# UNITED STATES PATENT AND TRADEMARK OFFICE

APPLICATION NO.	FILING DATE	FIRST NAMED INVENTOR	ATTORNEY DOCKET NO.	CONFIRMATION NO.
10/049,834	02/19/2002	Wolfgang Scheibe	842FR/50684	2328

## Office Action Summary

## DETAILED ACTION

**Examiner's Marked Up Figure #3**

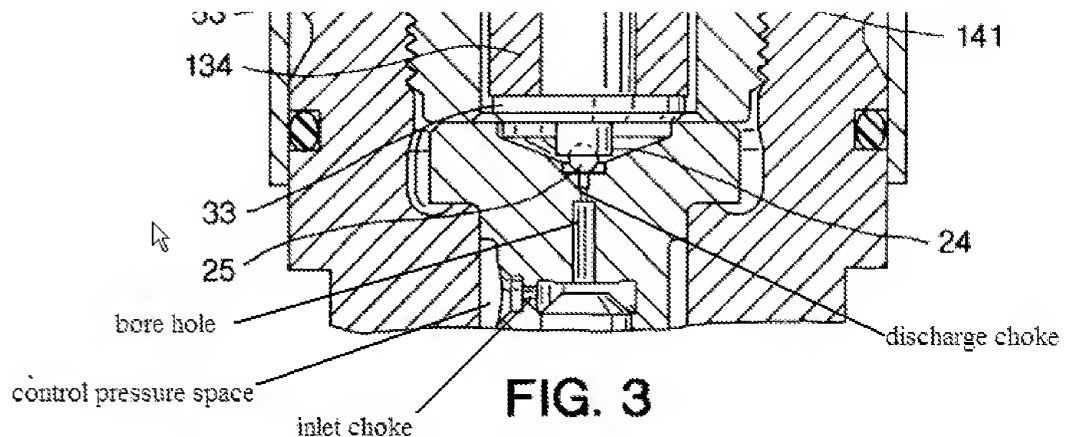
Regarding claims 14-19, and 31-37 the insert part (also forms a stop for the valve needle ) is formed in two parts with a first part, which contains an opening for the passage fluid and a discharge or outlet choke (see examiners marked up figure 3) and a second part at the control pressure space side, with a bore hole (see examiners marked up figure 3) which connects the control pressure space (see examiners marked up figure 3) with an opening for the passage of fluid. The second part contains an inlet choke (see examiners marked up figure 3) near the bore hole (see examiners marked up figure 3). The pressure space is connected with an inlet choke and the rear end of the valve needle (see examiners marked up figure 3) averted from the nozzle needle

seat surface lies in the control pressure space. The pressure insert part also including an inlet choke and an outlet or discharge choke (see figure below).

Regarding the applicant's arguments concerning claim 16, it is noted that the sealing surface is formed in the end face of a disk shaped insert part, the first part of the insert is disc shaped. Secondly, the insert part does include an inlet choke and an outlet choke, see figure 3 above.
